CUM3MS NOT CONSISTENT IN R129

Frank Brouwers

October 2015

Annex 17:

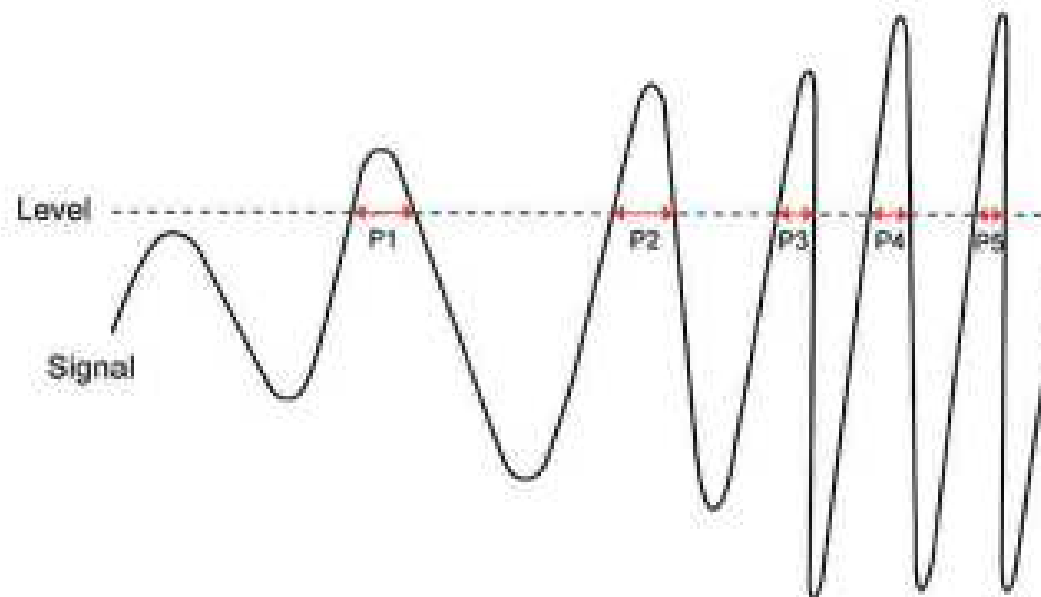
1.3. The value of the resultant **head acceleration** during **forward impact** which is exceeded **for 3 ms cumulatively** is calculated from the resultant head acceleration.

1.3. The value of the resultant head acceleration during forward impact which is exceeded for 3 ms cumulatively is calculated from the resultant head acceleration.²

Change Annex 17:

1.3. The value of the resultant head acceleration during **forward frontal, rear, and lateral** impact which is exceeded for 3 ms cumulatively is calculated from the resultant head acceleration.

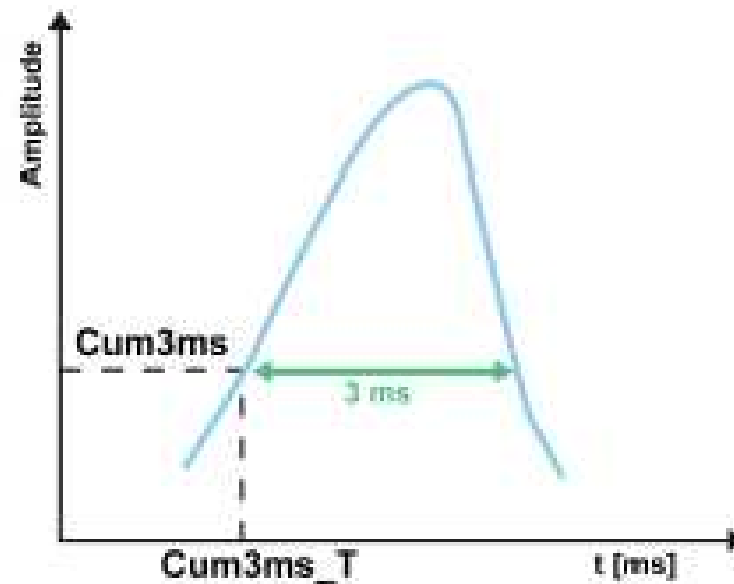
The Cum3ms can be calculated with one peak.

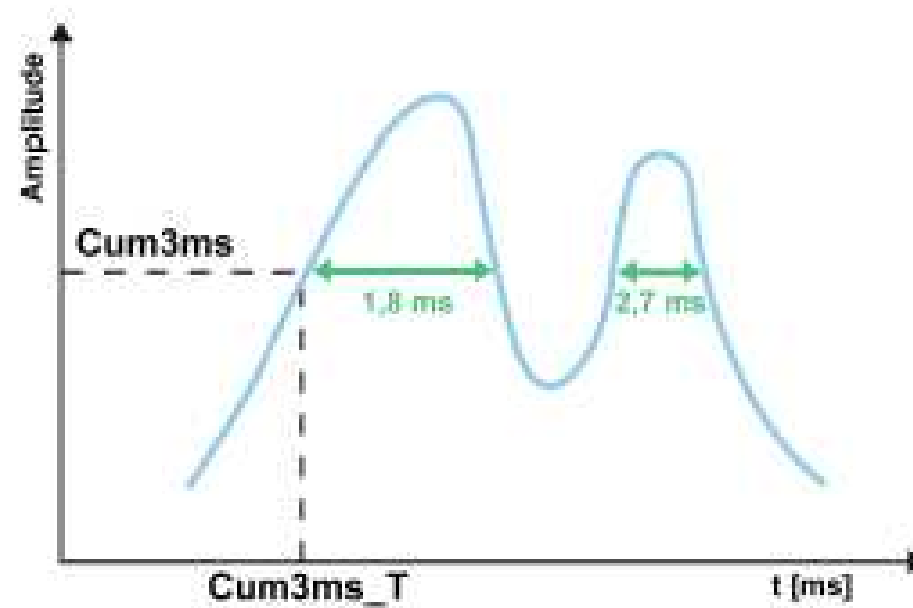
The Cum3ms can be calculated with several peaks.

Cum3ms: This function returns the highest acceleration level with a cumulative duration of at least 3ms (several peaks).
